Access Compliance Report Public Rights-of-Way (Curb Ramps)

Main Street: CALDWELL_LN		Cross Street: VINEYARD_RD		Location:	SE
ADA ID: RPAT211103112719	Ramp Type: Type 4 - Parallel	Initial Pass/Fail: Fail	Overall Compliance: No	Severity Score:	2

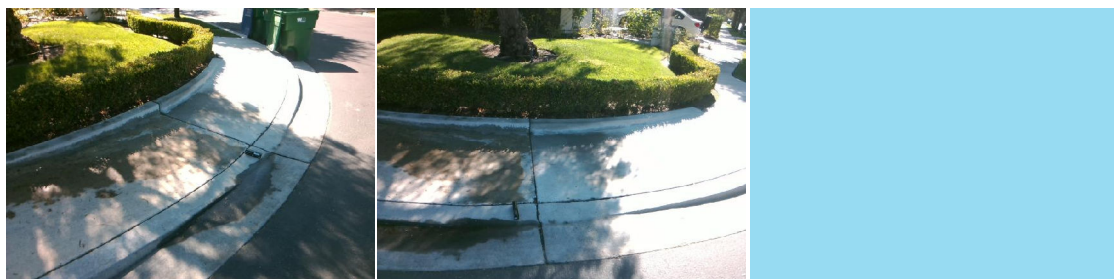
Compliance	Description	Data	Compliance	Description	Data
N/A	Ramp Length LT (in)	107	N/A	Ramp Length RT (in)	105
Yes	Ramp Width LT (in)	52	Yes	Ramp Width RT (in)	52
Yes	Ramp Run Slope LT (%)	5.3	Yes	Ramp Run Slope RT (%)	3.1
No	Ramp Cross Slope LT (%)	2.4	No	Ramp Cross Slope RT (%)	2.5
N/A	Landing Present	N/A	N/A	DWS Provided	N/A
N/A	Landing Length (in)	N/A	N/A	DWS Contrast	N/A
N/A	Landing Width (in)	N/A	N/A	DWS Length (in)	N/A
N/A	Landing Run Slope (%)	N/A	N/A	DWS Full Width	N/A
N/A	Landing Cross Slope (%)	N/A		DWS Offset Type	N/A
N/A	Landing Movement Obstructed?	N/A	N/A	DWS Offset Left (in)	N/A
	Landing Movement Type	N/A	N/A	DWS Offset Right (in)	N/A
N/A	Landing Shared	N/A			
N/A	Clear Space	Yes			
N/A	Clear Space To Crosswalk (in)	N/A			
N/A	Marked Crosswalk 1	No	N/A	Marked Crosswalk 2	No
	Crossing 1 Direction	N		Crossing 2 Direction	W
	Marked Crosswalk 1 Width (in)	N/A		Marked Crosswalk 2 Width (in)	N/A

Remove & Replace Curb Ramp With Two New Directional Ramps or Equivalent.

R204.3, R304.5.3, STD 1115
